**MONTGOMERY COUNTY HISTORIC PRESERVATION COMMISSION**  
**STAFF REPORT**

<b>Address:</b>	30 Hesketh Street, Chevy Chase	<b>Meeting Date:</b>	1/6/2021
<b>Resource:</b>	<b>Contributing Resource</b> Chevy Chase Village Historic District	<b>Report Date:</b>	12/30/2020
<b>Applicant:</b>	Kristen Donoghue and Jonathan Hacker (Neal Thomson, Architect)	<b>Public Notice:</b>	12/23/2020
<b>Review:</b>	HAWP	<b>Tax Credit:</b>	NA
<b>Permit Number:</b>	936072	<b>Staff:</b>	Michael Kyne
<b>PROPOSAL:</b>	Partial demolition, roof replacement, fenestration alteration, and construction of a rear addition

Title **Proposed First Floor**

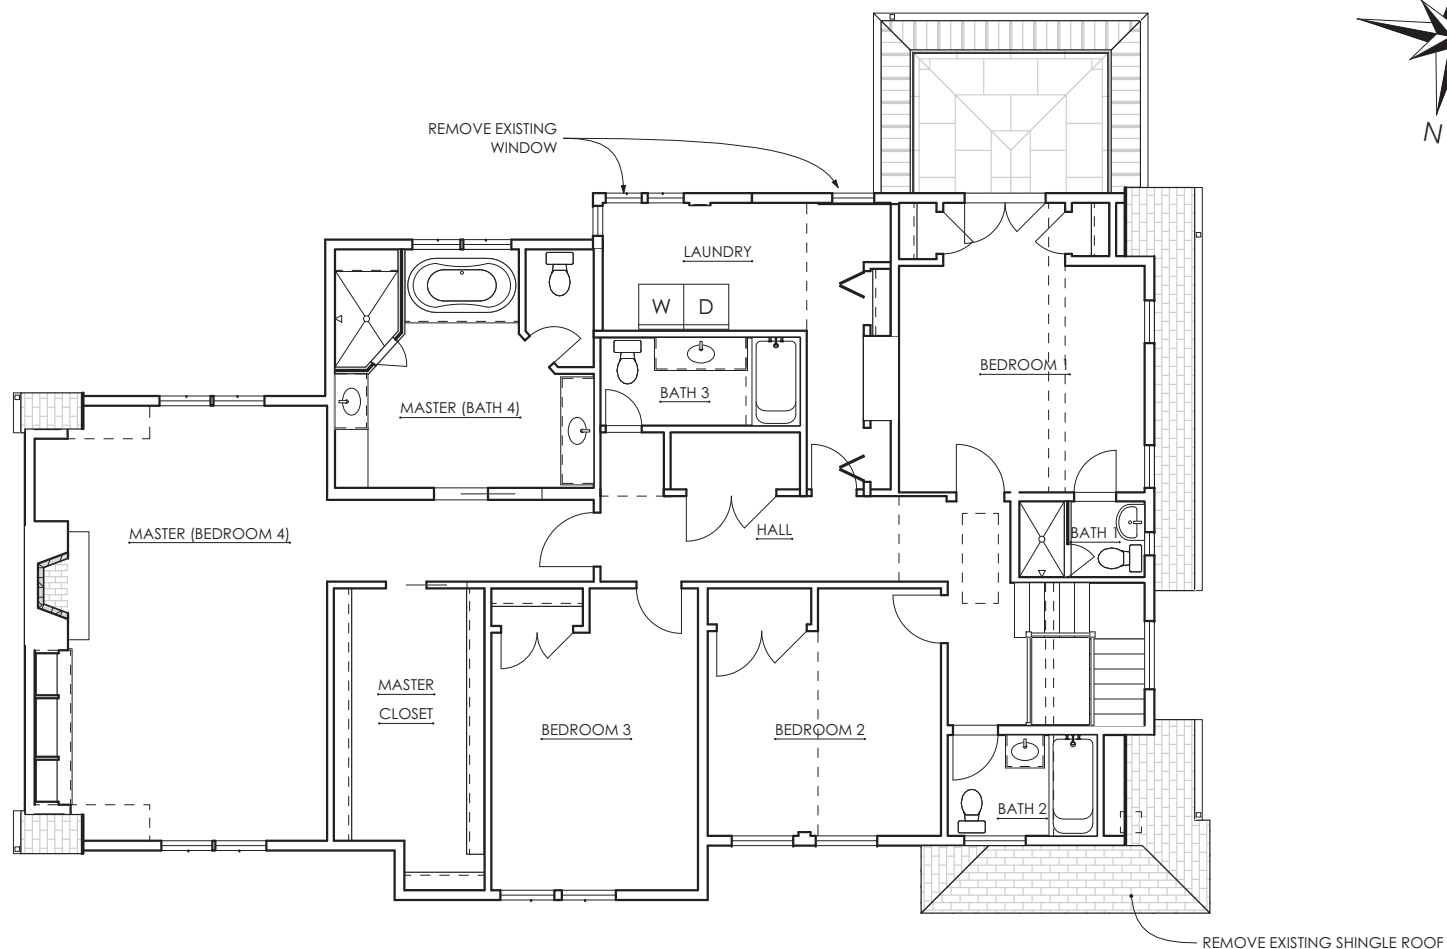
Staff supports the applicants' proposal, finding it consistent with the *Guidelines*. The proposed addition is in the preferred location at the rear, and, due to its minimal size and location, it will not be visible from the public right-of-way. Accordingly, the addition and the proposed materials should be reviewed with lenient scrutiny. Staff also finds the proposed addition materials to be appropriate and compatible with the subject property and surrounding streetscape.

Project	Donoghue Hacker Residence 30 Hesketh Street Chevy Chase MD 20815		10	
Title	Proposed Roof Plan		Date	12/10/2020
Scale	3/32" = 1'-0"	Sheet Ref

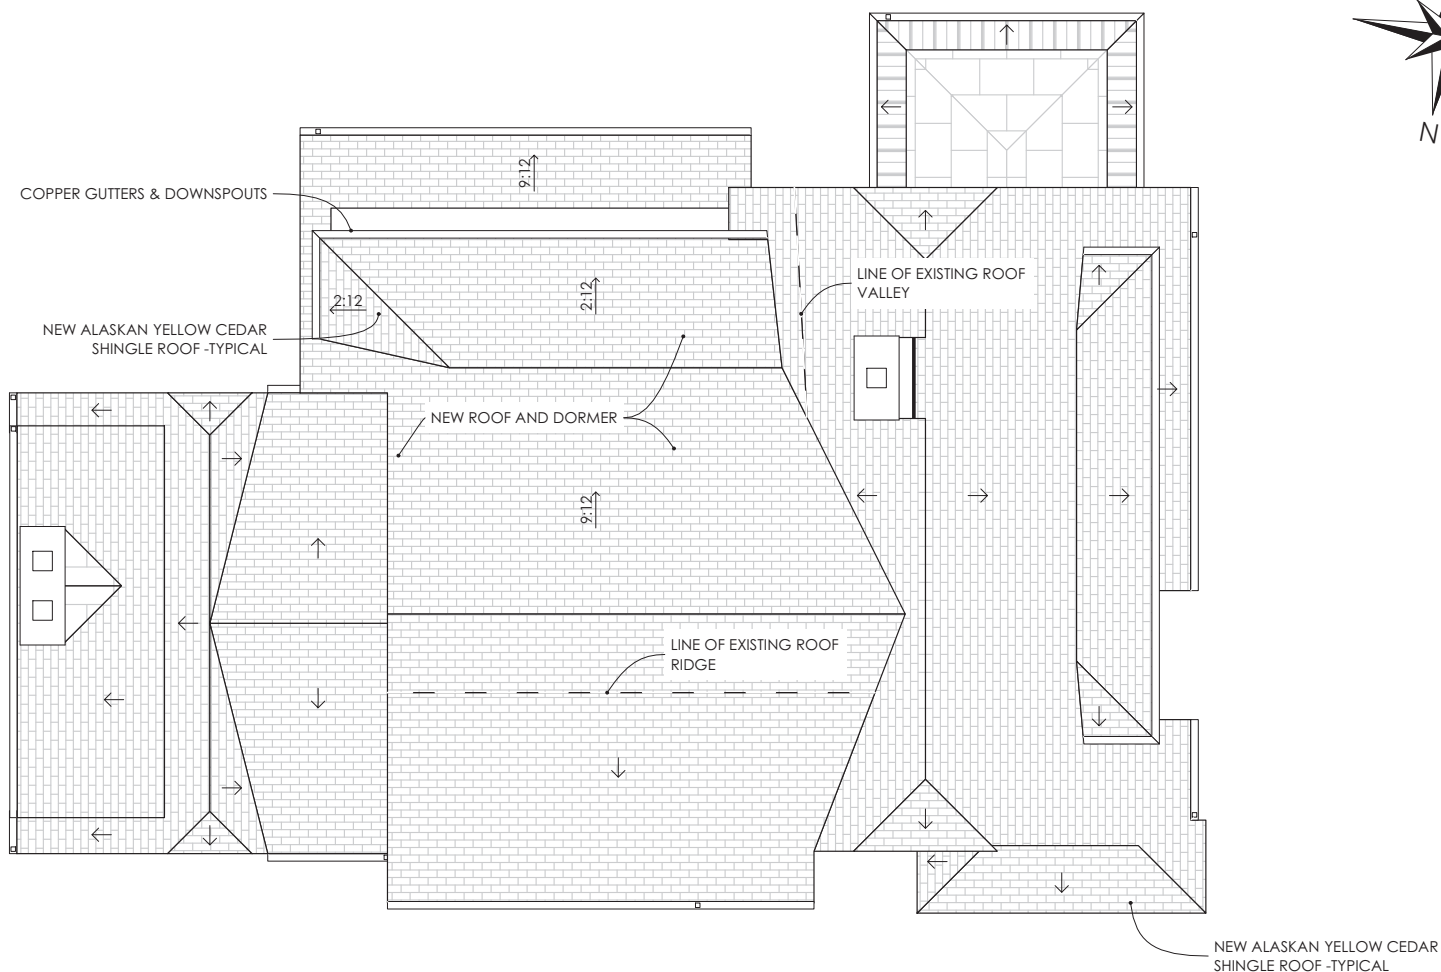
Staff finds that the proposed alteration to the ridge of the historic house roof is generally compatible with the subject property and surrounding streetscape. As viewed from the public right-of-way, the roof will retain its existing shape, form, and slope, and the scale and massing of the subject property house will remain consistent with the surrounding properties. With the proposed alteration, the property will continue to contribute to the district.
